Technical Note – TN mipi1

Subject CRUVI for the 4-lane CSI2 Camera

Objective Compatibility with RPi5 cameras on one side,
and Trenz TEB0707-02 Carrier Card with TE0711-01 FPGA SOM on the other

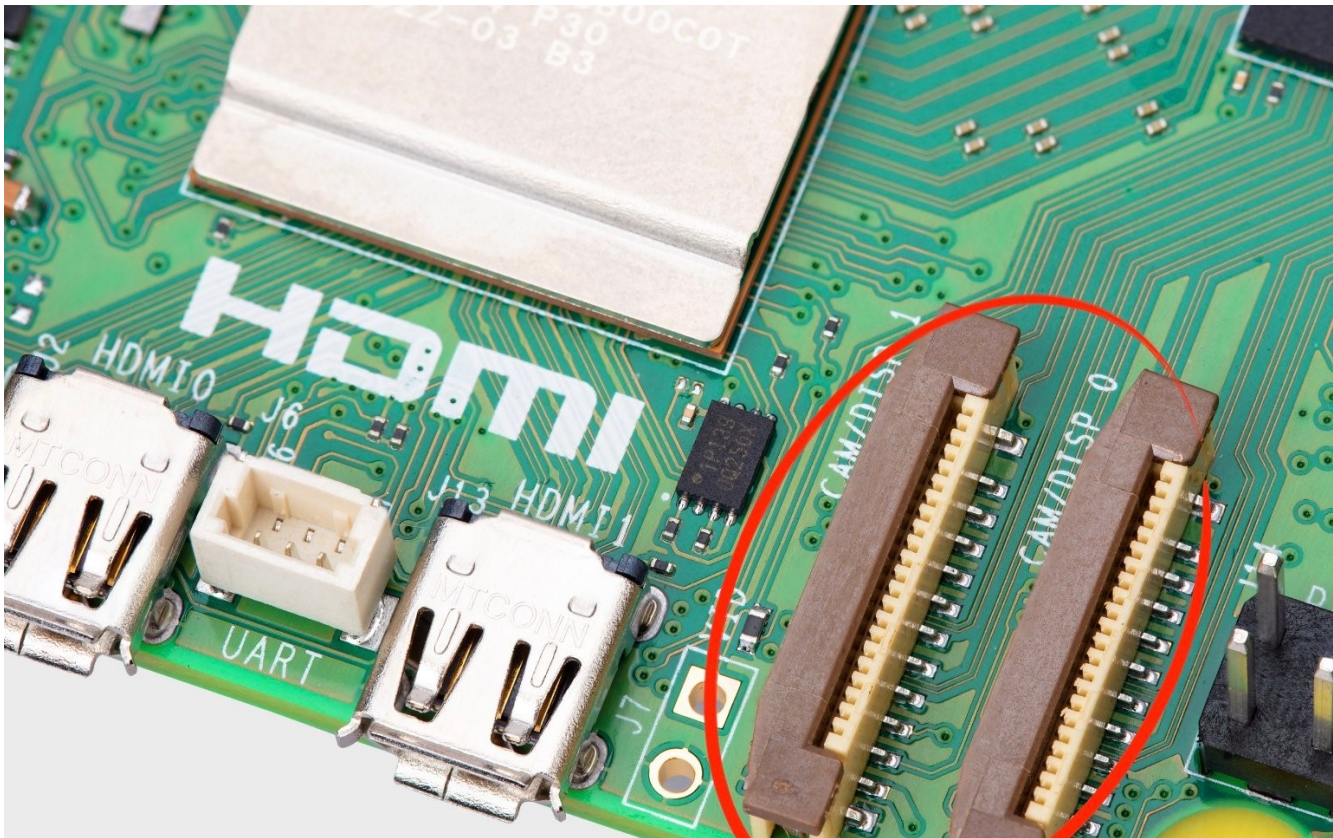
However, the current CRUVI connector design is assuming the use of “*Opposite Contacts*” “Mini” cable. While such cables exist and can be purchased separate from the camera, they are not a norm. Indeed, the cable that comes with 4-lane IMX283 camera does not have “*Opposite Contacts*”.

- **The use of incorrect cable results in a direct short of the 3.3V camera supply.**

The rule to apply is very simple: The camera side of CRUVI connector must be pinned exactly like the RPi5 MIPI connector.

Current J1 CRUVI Pinout:

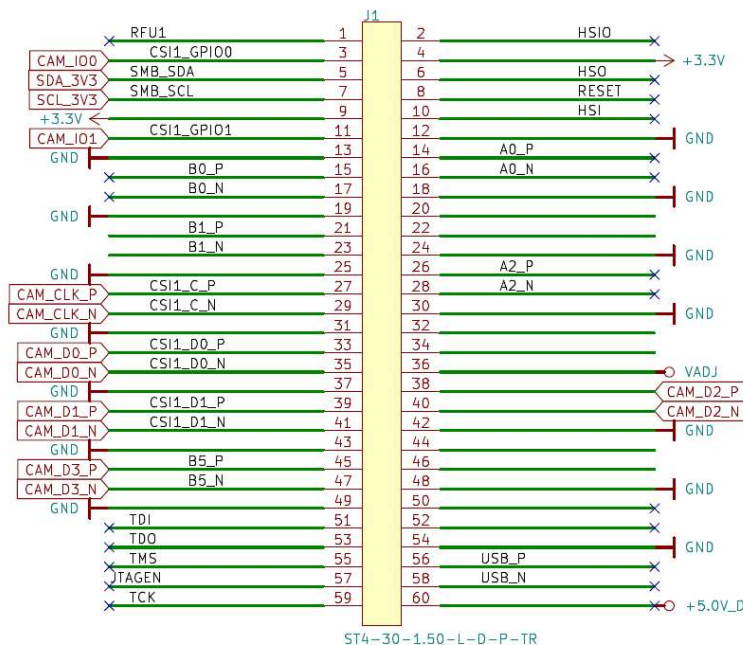
Another, though less critical issue with the current CRUVI connector, is the signal mapping towards Trenz Carrier Card, which connects camera I2C pins to the on-board CPLD. This means that, for the SOM FPGA to get to camera I2C, the user needs to alter the CPLD program. While doable, this incurs unnecessary work and complications.

- 1) No connection is to be fed through CPLD. All camera lines must have direct wiring to SOM FPGA
- 2) High-speed Clock pair should connect directly to LVDS FPGA Clock Capable (CC) pin
- 3) High-speed Data links should connect to LVDS FPGA pins in the same banks as the Clock / CC pin
 - If possible, place Data in the close proximity of Clock, ideally with Clock right in the middle
- 4) If possible, find the pinout that adheres to these rules for all 3 CRUVI locations on the Carrier Card
